Project description: Remodel an historic stone wall along the streetscape. An exception to remove historic material is requested to Sections 14-5.1 General Purpose and Relationship to General Use Zoning Districts, 14-5.2 (C,1,a,c and d) Regulation of Contributing Structures, 14-5.2 (D,1,a and b) General Design Standards for All H Districts, and 14-5.2 (D,5,a,ii and b) Design Standards for Windows, Doors, and Other Architectural Features.

Project number: 04-10100114
Case number: H-04-114
Project type: HDRB

PROJECT LOCATION (S): 511 Paseo de Peralta

DATE: June 26, 2007
TO: Historic Design Review Board Members
VIA: Reed Liming, Long-Range Planning Division Director *RL*
FROM: David Rasch, Supervising Planner in Historic Preservation *DR*

entire driveway
opening

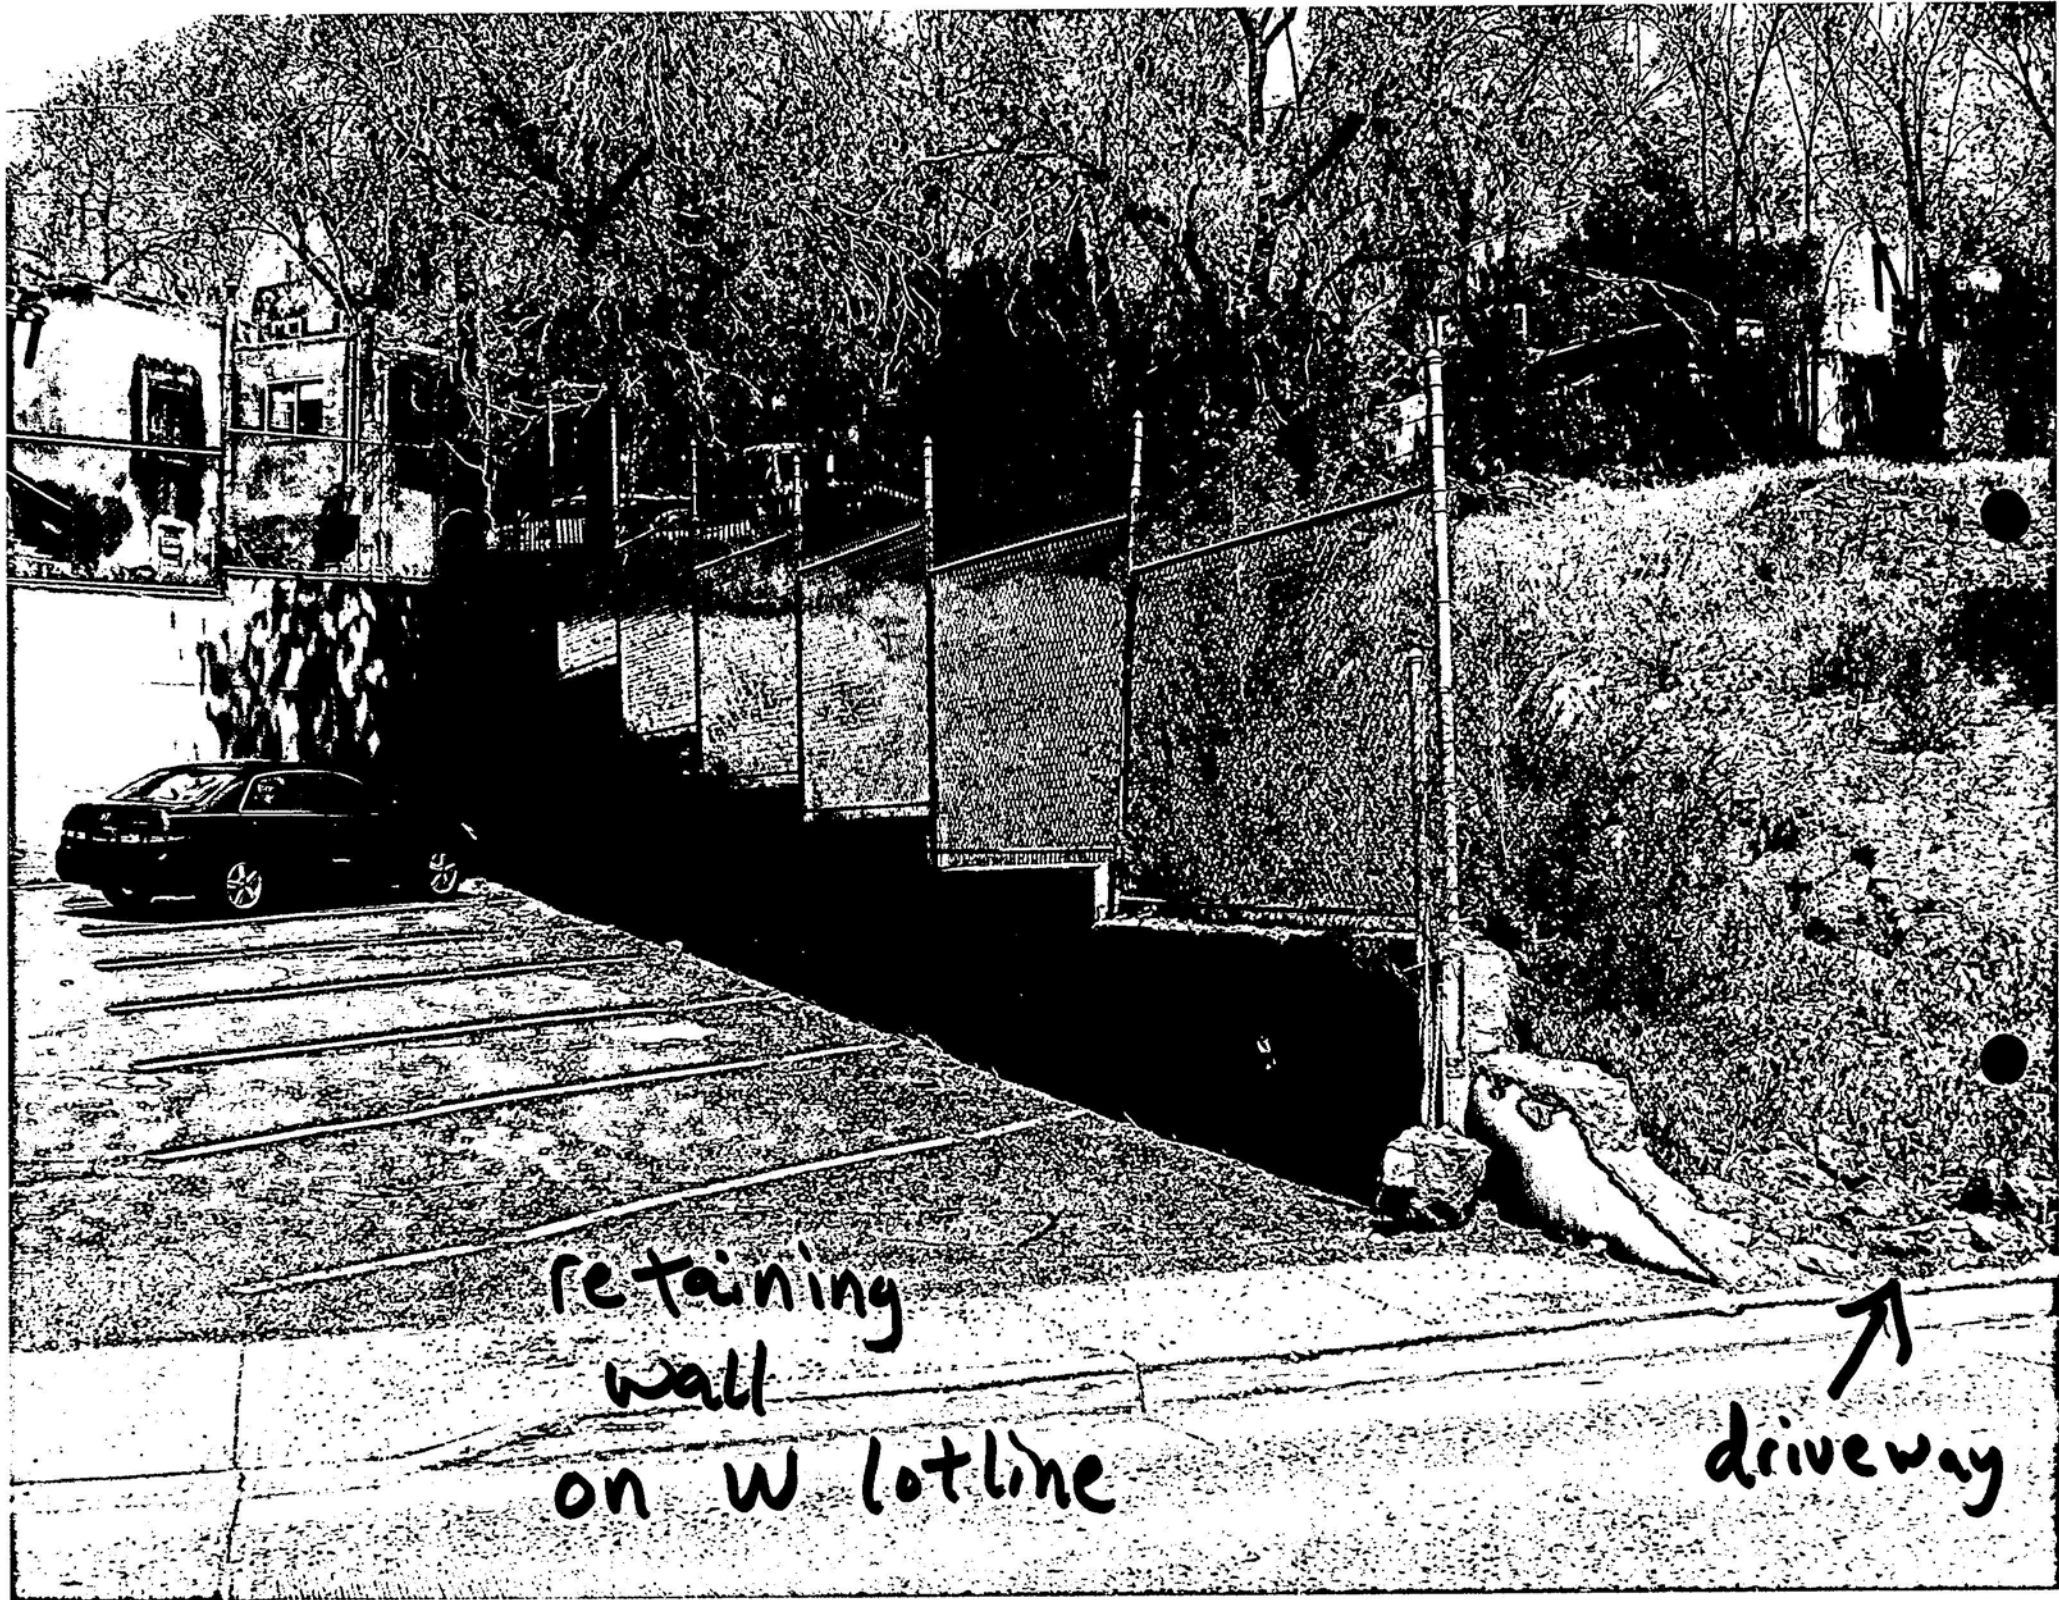
The wall as it stands does not allow sufficient sight distance to allow safe egress from the lot. There is no other ingress and egress to the lot.

There is no manner to lower the height of the existing wall. The wall is approximately 125 feet wide and 18 inches thick, making it impossible to cut through and lowered. In addition the wall could not withstand such impact and would most likely fall apart. A stucco wall is the most prudent approach as it blends into the surrounding area, and does not mimic a historic wall.

-PASEO COMPOUND-
511 PASEO DE PERALTA

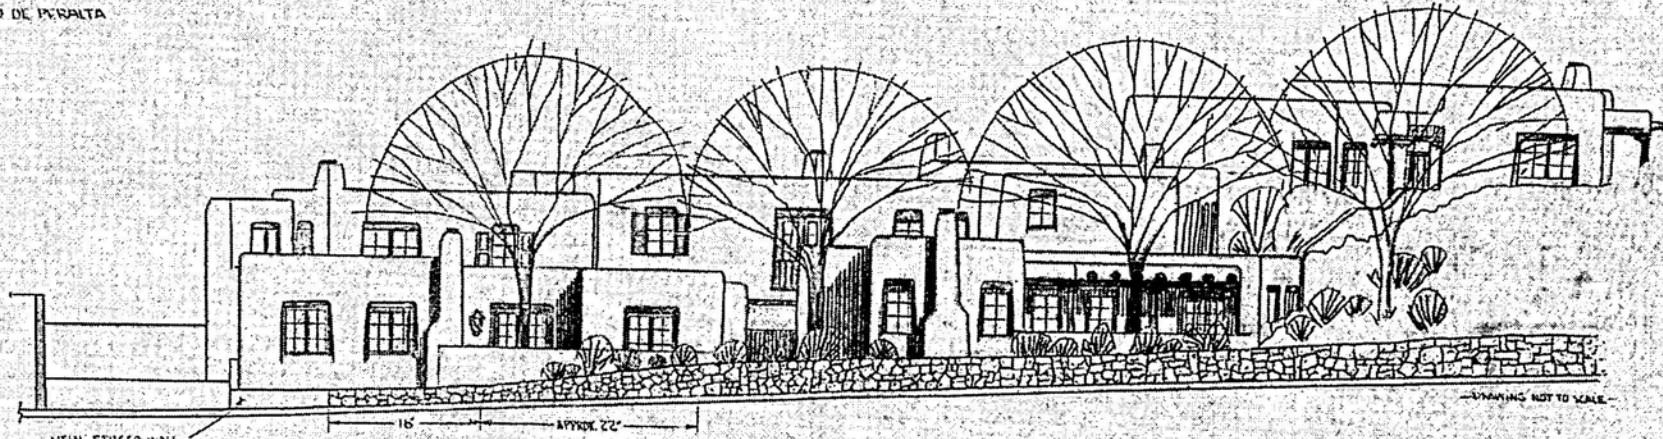
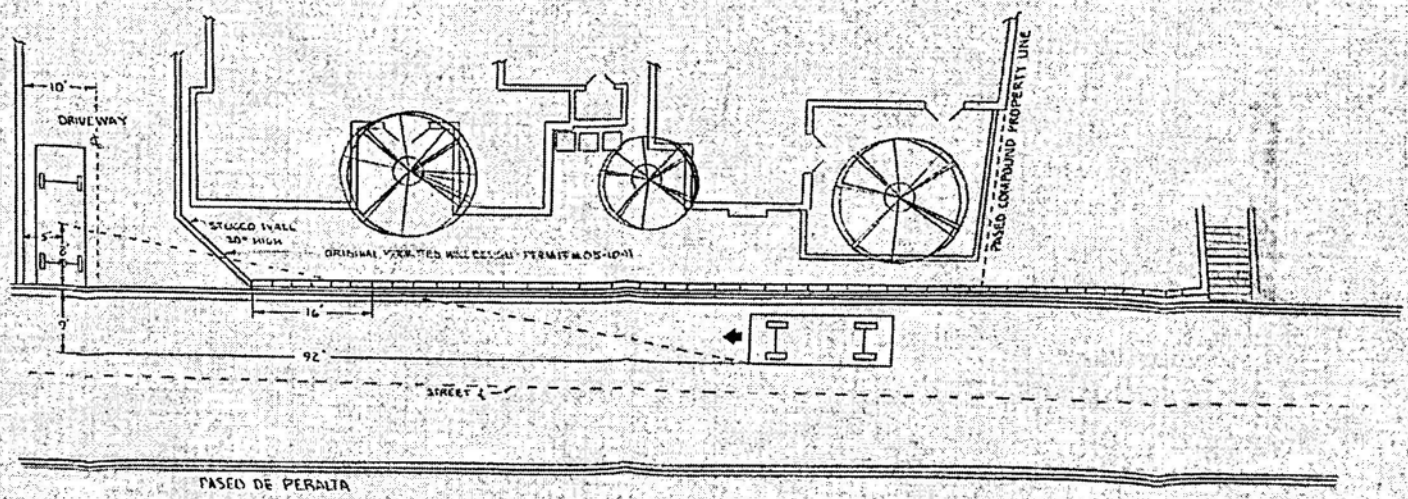
The request of Public Works is to demolish most of the historic stone wall in order to provide site safety triangle for exiting the property. That request was denied by historic in May 2007. This current request angles the existing wall and requires the wall to be lowered to 36 feet from the ground elevating at an angle lowering the wall height but allows the remaining wall to be left in tact. Thus maintaining the character of the streetscape for which the wall is an important part of.

If approved the lowering of the wall would require the wall to be removed stone by stone in order to preserve the lower portion of the wall. The wall is approximately 125 feet wide and 18 inches thick, making it impossible to cut through and lowered. A special precaution would need to be taken care of in order to protect the wall and allow it to withstand with such impact. (sic)

- NOTES:
1. WITHIN THE 16' AREA THE STONE WALL IS 36" ABOVE THE ROAD SURFACE.
 2. WITHIN THE 22' AREA THE STONE WALL RISES FROM 36" ABOVE THE ROAD SURFACE TO MEET THE ORIGINAL WALL HEIGHT.

PREVIOUSLY H-BOARD APPROVED

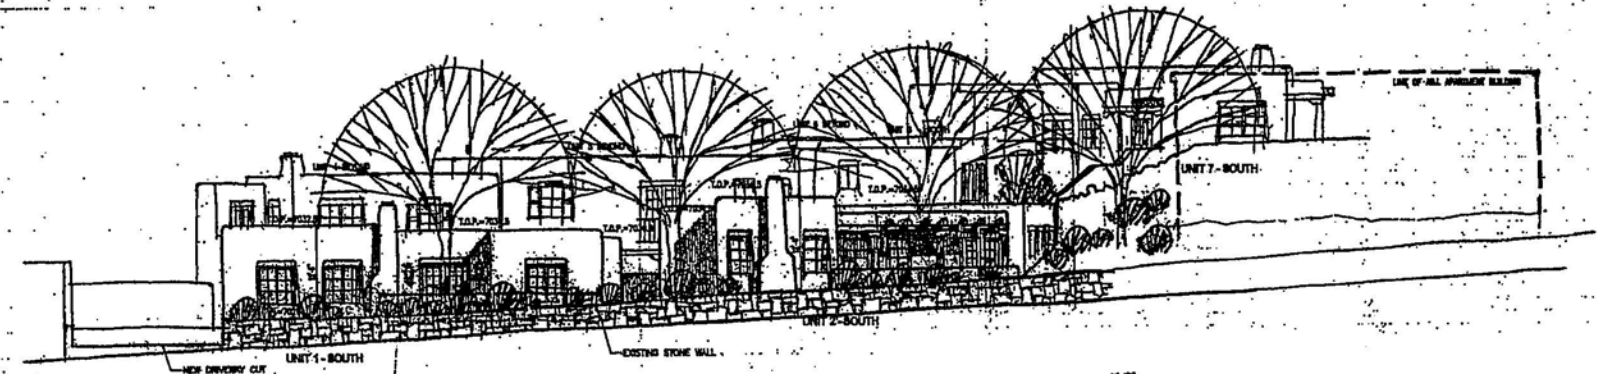
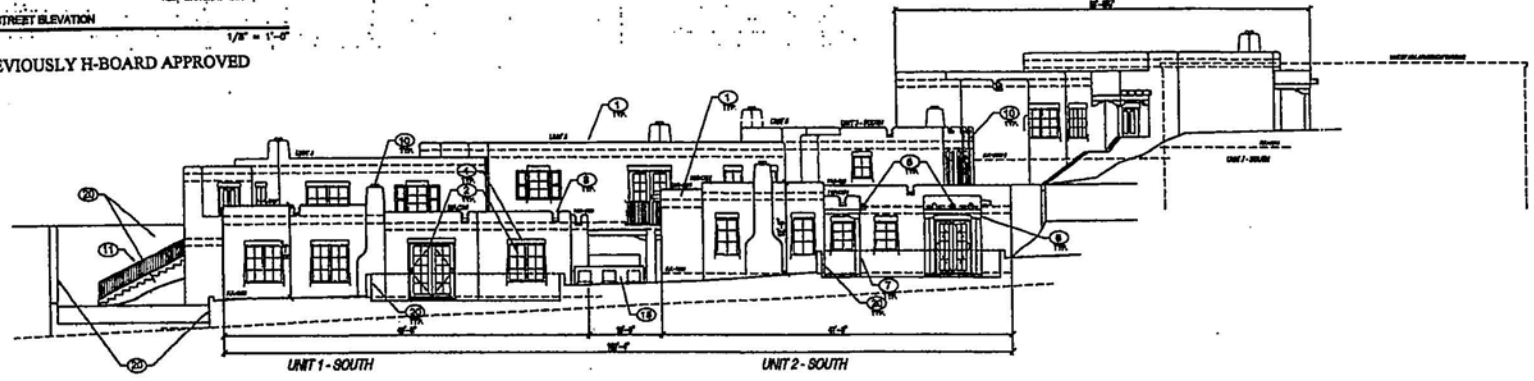
Present and sworn was Mr. Steve Russell, 105 Camino Encantado, who showed each change (highlighted in yellow) beginning with the streetscape area. He said some portal reductions were to reduce lot coverage to less than 40% and acknowledging that the previous approval meant they had exceeded 40% of lot coverage. He said the windows that were removed were taken out because of the code requirements on zero lot line building.

Mr. Bell said the staff report emphasized an overall change on the drawings. He pointed out that the old drawings were a different style. He pointed out that the new, non-battered walls and non-rounded edges were very different.
